AGENDA
WORCESTER TOWNSHIP PLANNING COMMISSION
WORCESTER TOWNSHIP COMMUNITY HALL
1031 VALLEY FORGE ROAD, WORCESTER, PA 19490
THURSDAY, MAY 22, 2025 - 7:00 PM

COMMERCE PURSUIT CAPITAL TROOPER RIDGE SUBDIVISION 1025 NORTH TROOPER ROAD, WORCESTER TOWNSHIP, MONTGOMERY COUNTY, COMMONWEALTH OF PENNSYLVANIA

3. While a Zoning Data table is supplied on Sheet 2, compliance of Lot 1 cannot be verified as the plan does not depict the entirety of proposed Lot 1. The plan must be revised to show the full extents of Lot 1. Additional zoning comments may apply upon future submission of Lot 1 details. (150-68, 150-84 and 130-33.B.4)

DESIGNED BY JPK/CKS/CMR/ROP/ZHR	DRAWING ENS
CHECKED BY BGS/ZHR	SHEET 14
DRAWN BY SCR/CKS/RAM	OF 46
DATE 12/19/2024	PROJ. NO. WDEV00004
SCALE AS NOTED

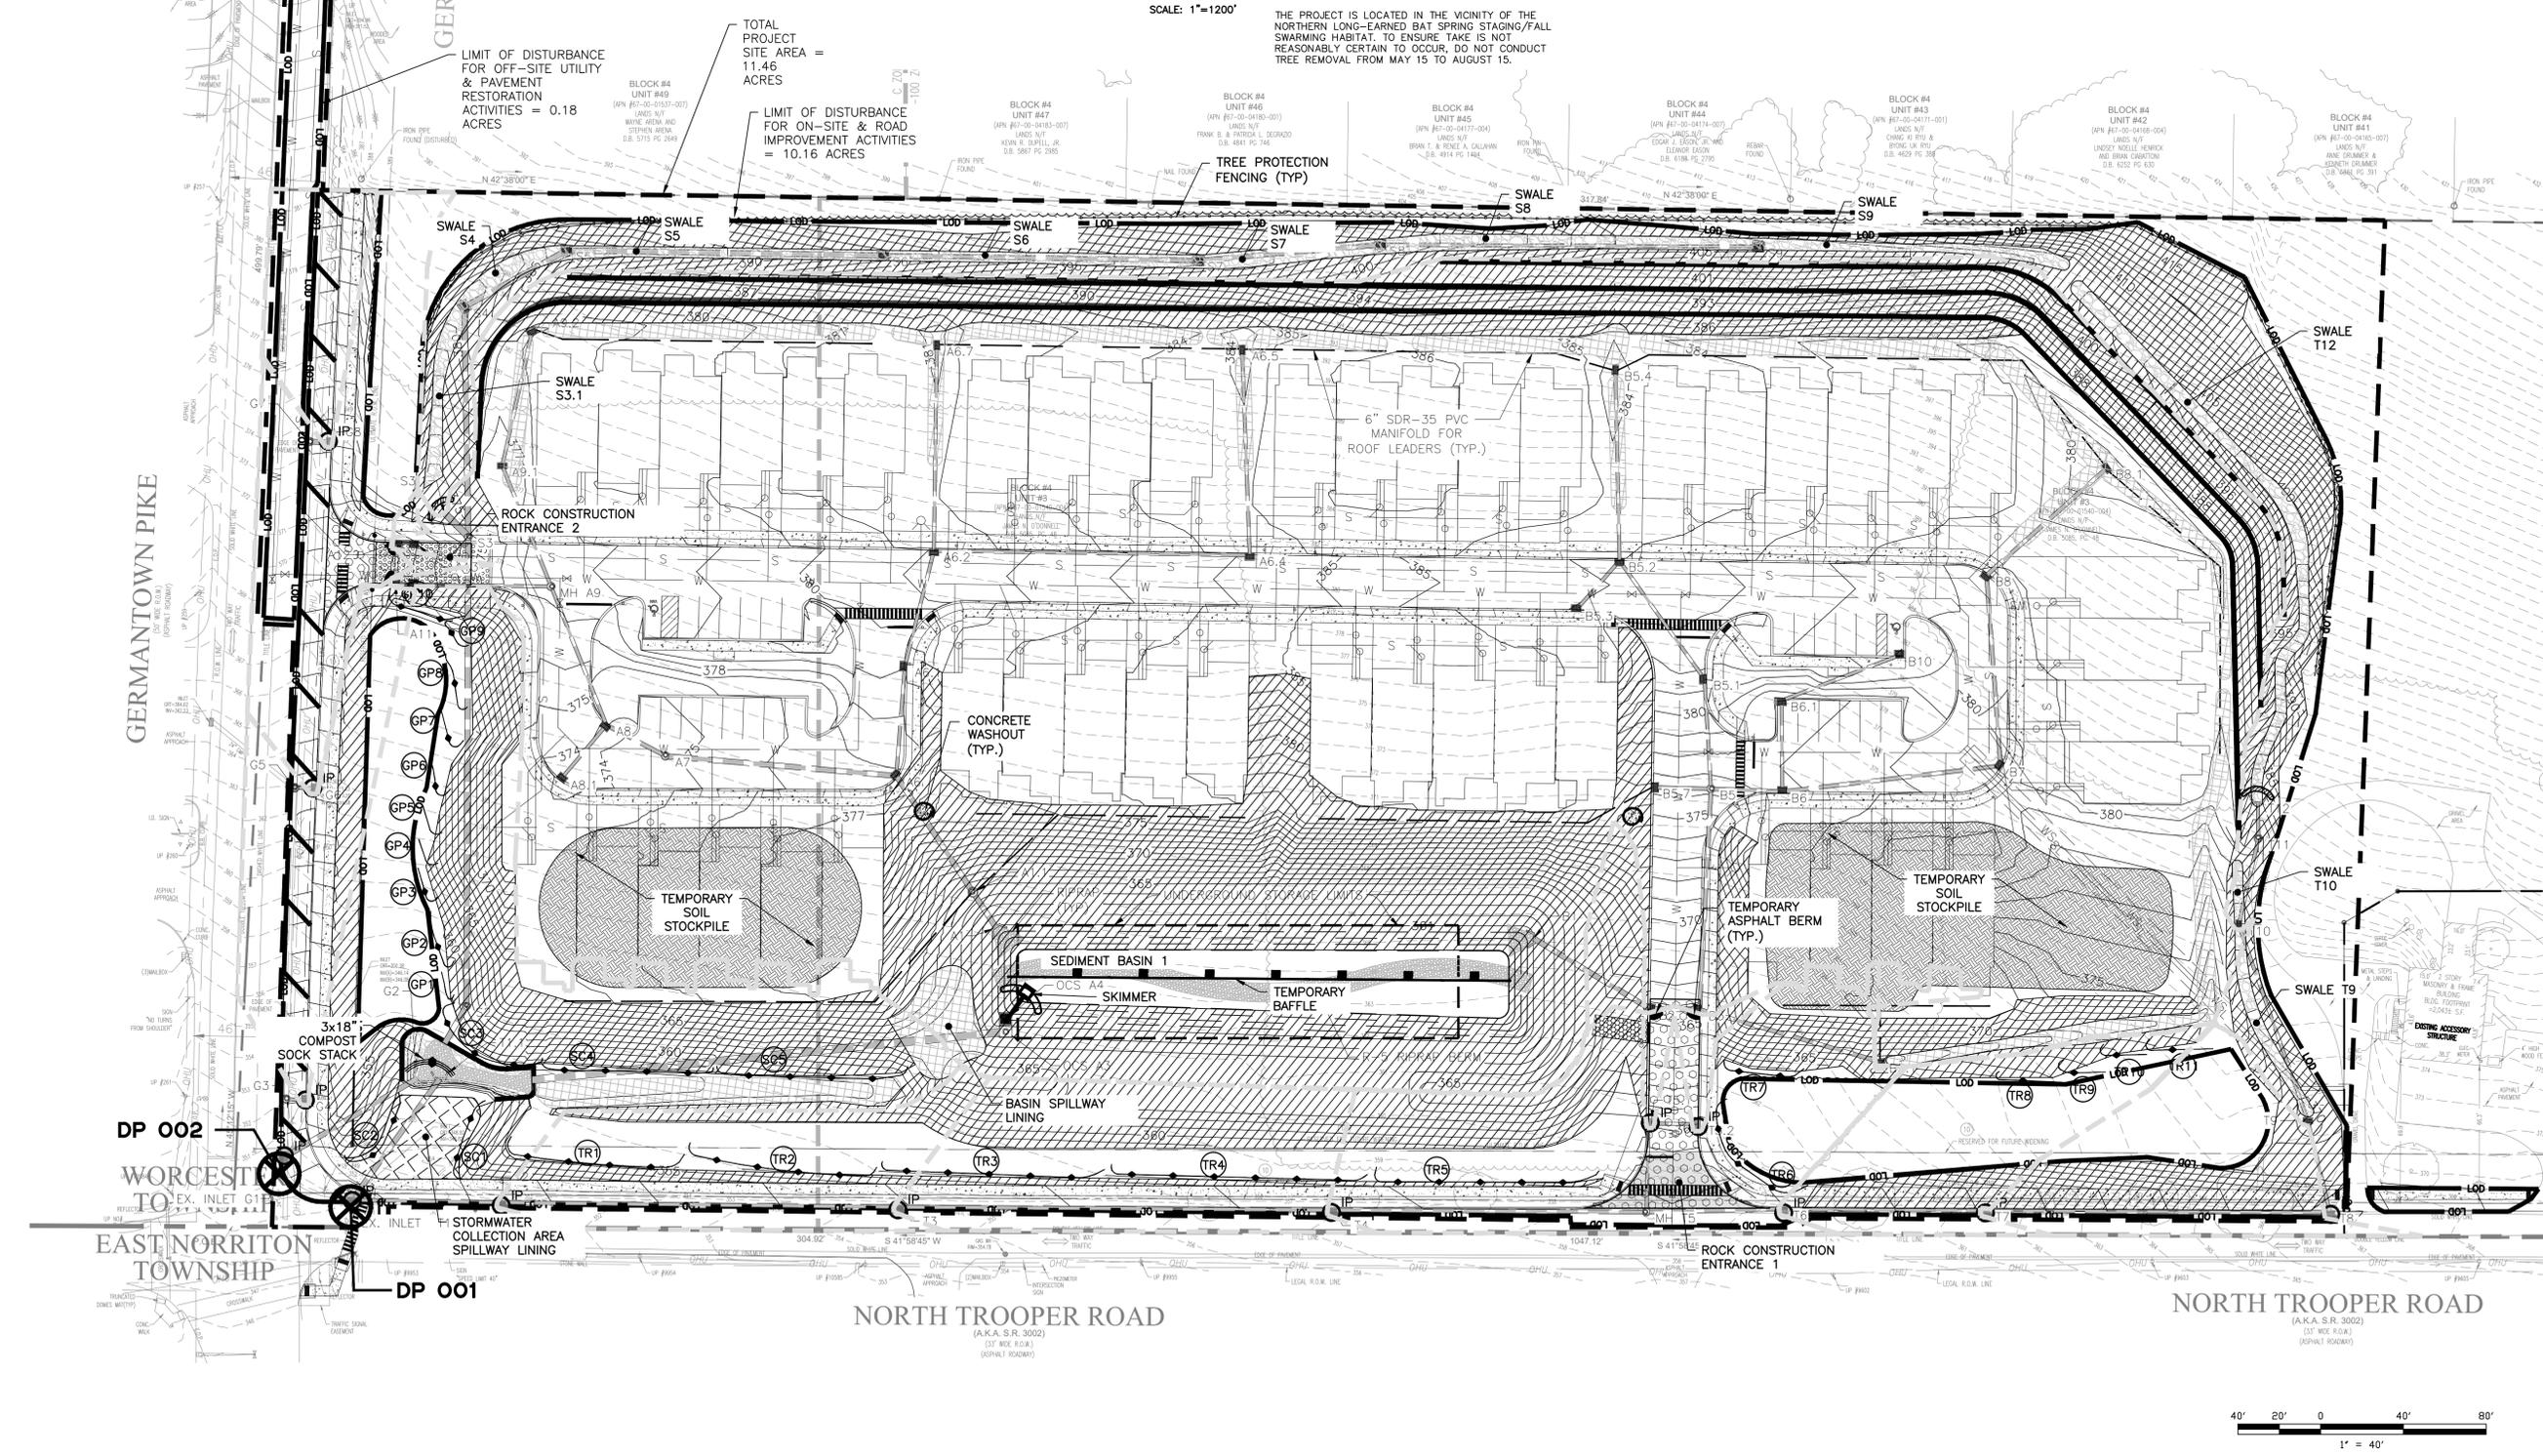
- c. A tree protection fence installation detail has been provided. The limits of the protection fencing are to be depicted on the Erosion and Sediment Control Plan (Sheet 11).

T&M Response: Tree protection fence has been added to the E&S Control Plan on Sheet 14.
